**UPPER UWCHLAN TOWNSHIP  
PLANNING COMMISSION  
AGENDA  
October 10, 2019**

July 3, 2019

Reference: Windsor Baptist Church – Proposed School Building  
Preliminary Land Development / Conditional Use Review  
Upper Uwchlan Township, Chester County, PA

### LAND DEVELOPMENT PLAN

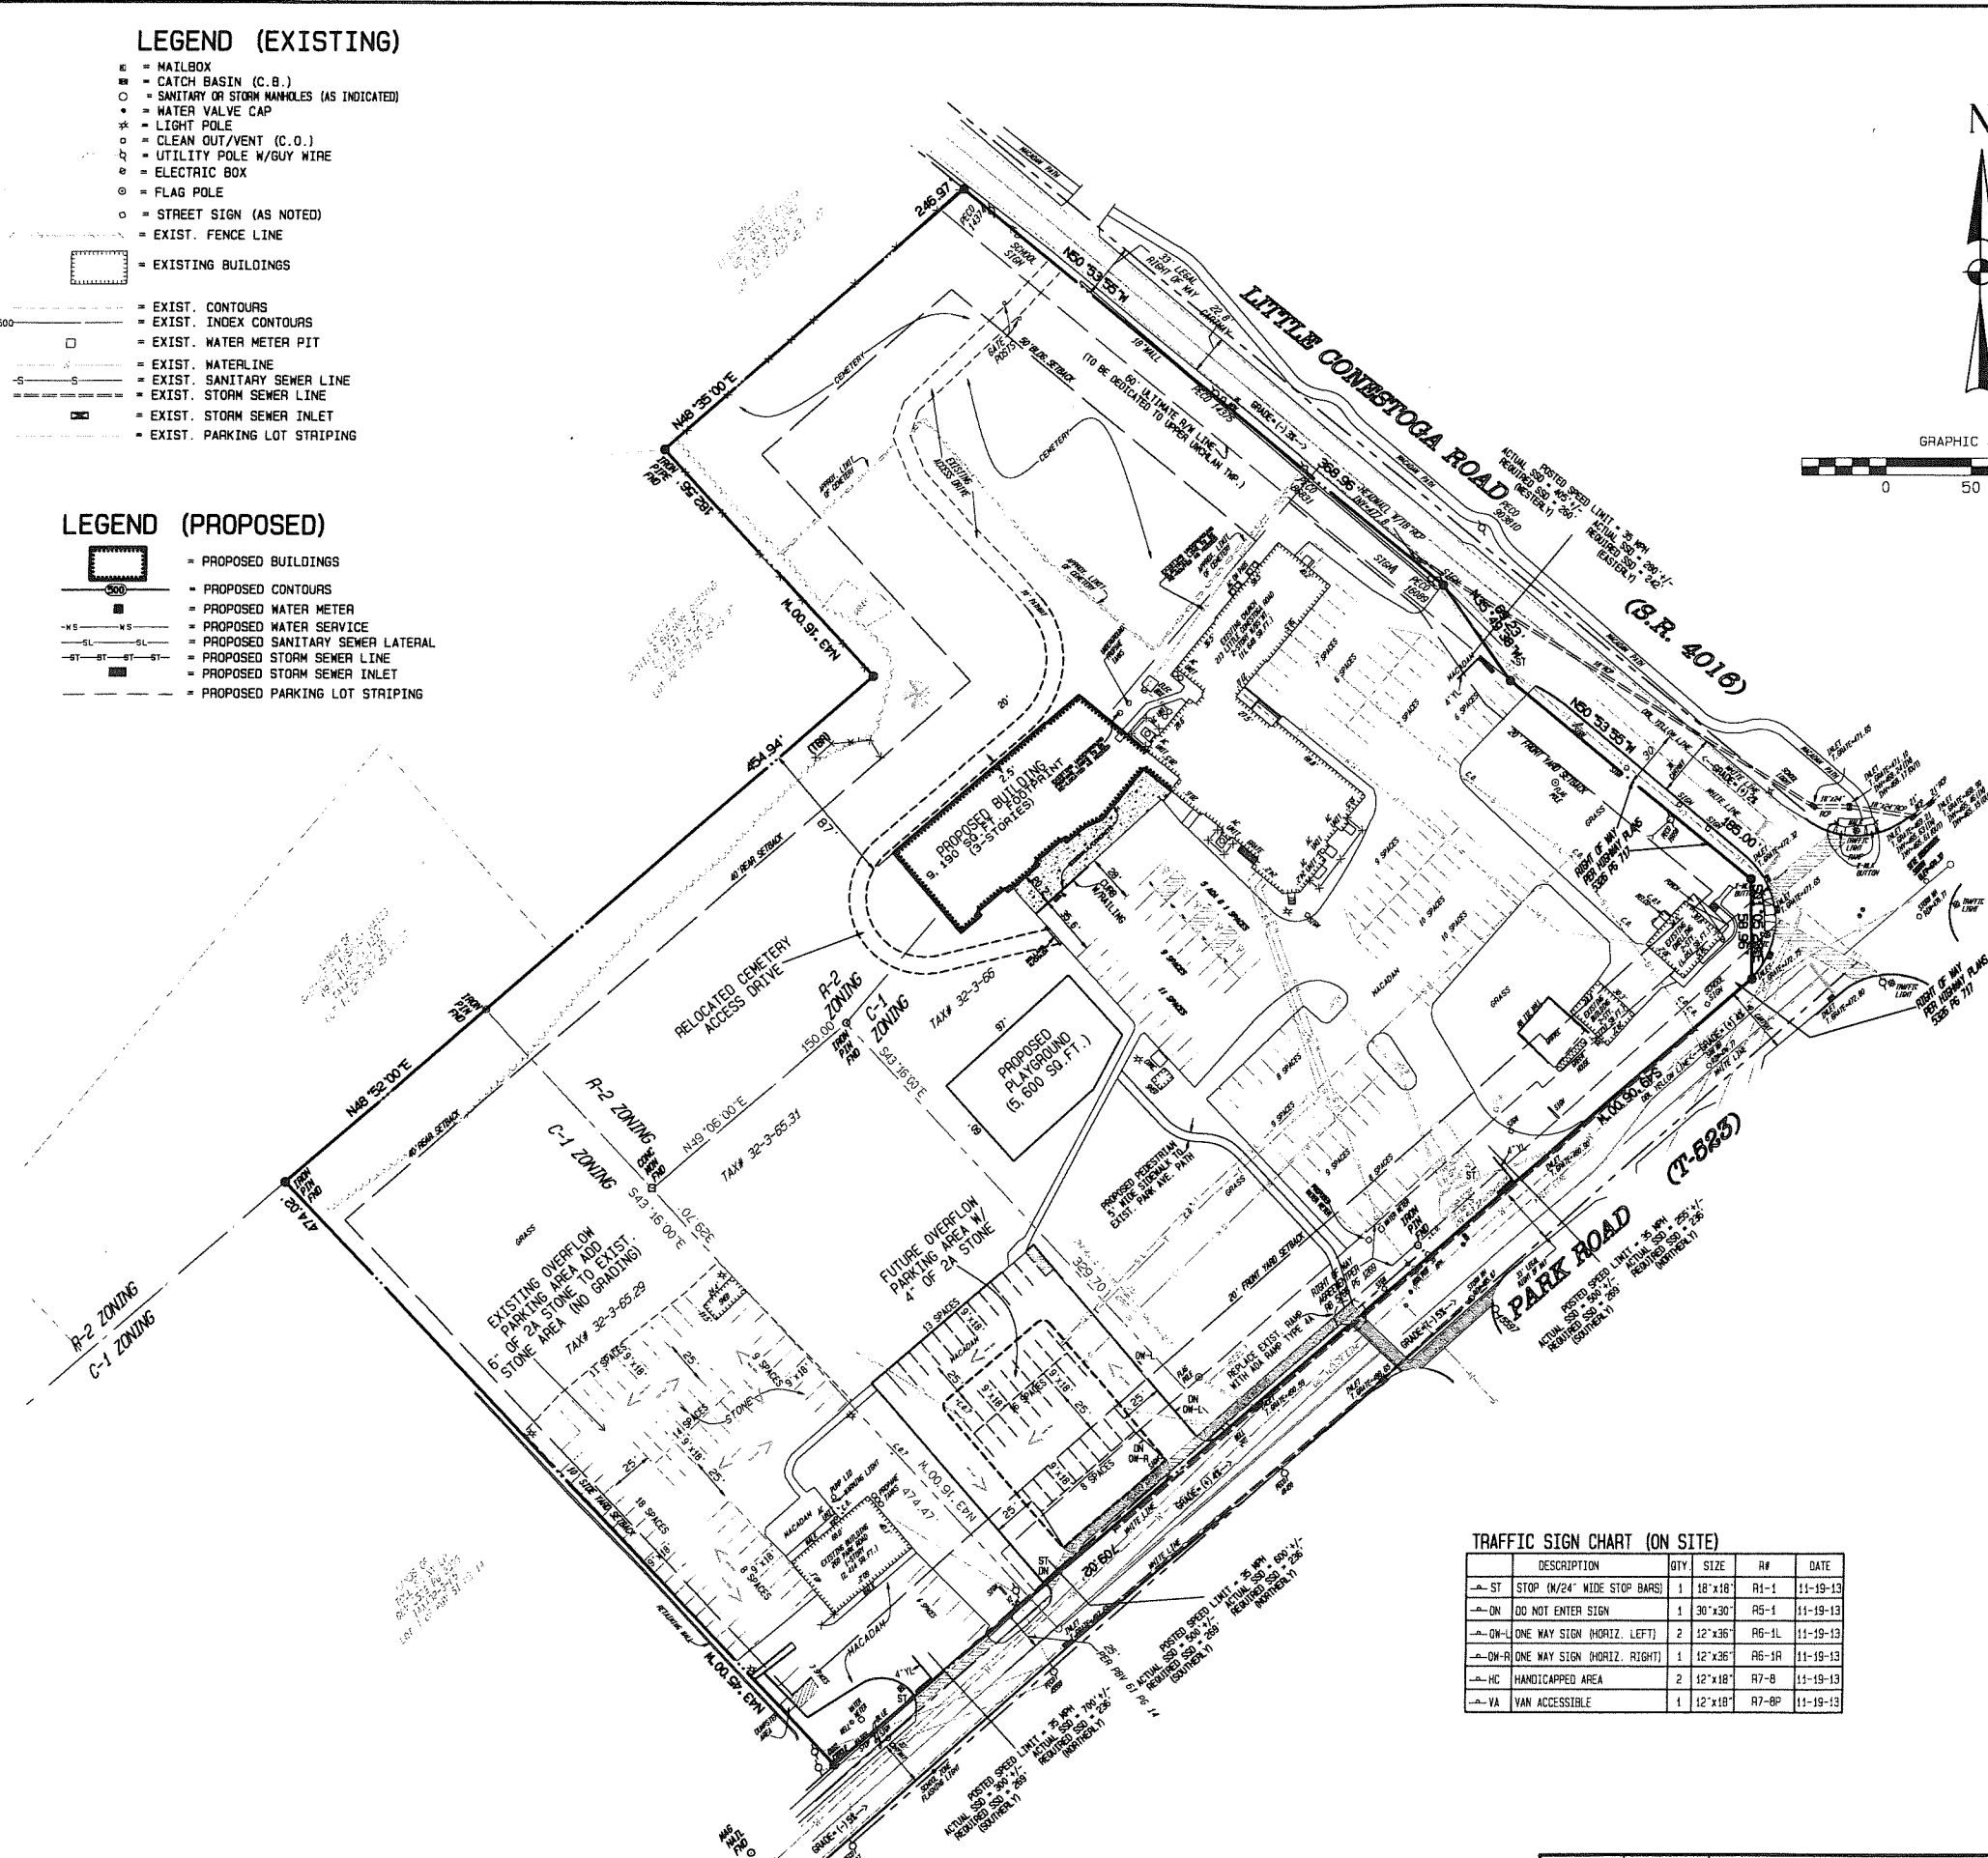
2. The Traffic Sign Chart (On Site) on the Land Development Plan does not appear to reflect the correct number of proposed stop signs and ADA signs. Also, please indicate the significance of the date of "11-19-13" in the date column.

6. ZO Section 200-73.D(5) – The plans should be revised to indicate the new handicap parking space pavement markings are proposed (not existing).
7. ZO Section 200-73.H(3) – The proposed parking supply for the site includes 140 paved parking spaces, and 84 gravel parking spaces, for a total of 224 parking spaces. This parking supply exceeds the parking supply requirements separately for the Church use (160 spaces required), and the combined day care/school use (171 spaces required). However, the paved parking supply (140 parking spaces) does not meet either of these requirements. As such, the Township should determine whether the spaces shown as gravel, overflow spaces at 250 and 260 Park Road should be improved to paved parking spaces.
